IMPORTANT! U34 Safety Recall Update

TO: ALL ALFA ROMEO GROUP DEALERSHIPS IMPORTANT U34 SAFETY RECALL UPDATE WATER INTRUSION ON 2018 ALFA ROMEO STELVIO LIFT GATE

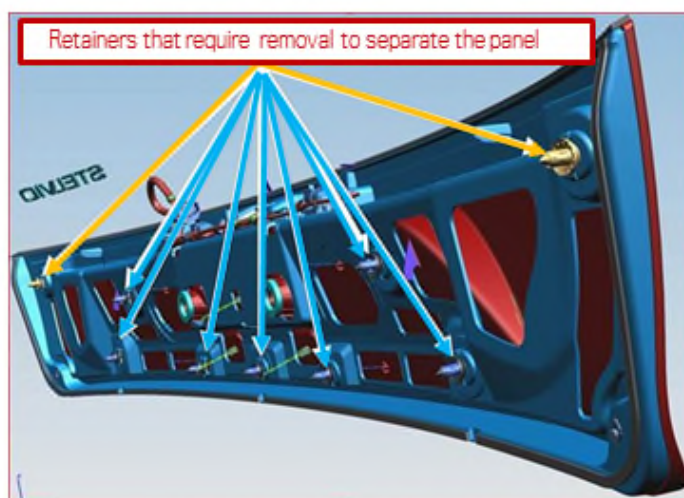
When removing the interior trim panel of the lift gate *please exercise care*. The clips utilized require the inner retainer to be released from the clip housing prior to pulling on the panel. Please reference the picture below showing the number and location of the trim clips. Please utilize:

- A trim remover tool (Special tool # C-4829A) or suitable trim stick to release the clips.

To remove the clip, slip a trim removal tool under the head of the retainer (shown in yellow) and press upwards.

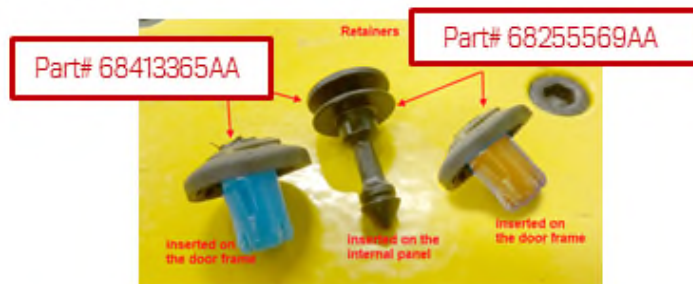
**Part#
68255569AA
(Qty 2)**
*designated by
yellow arrows
below*

**Part#
68413365AA
(Qty 7)**
*designated by blue
arrows below*

If, in the process of the recall repair, the clips are damaged, replacement clips will be available through Mopar. Below are descriptions and photographs of the parts for reference.
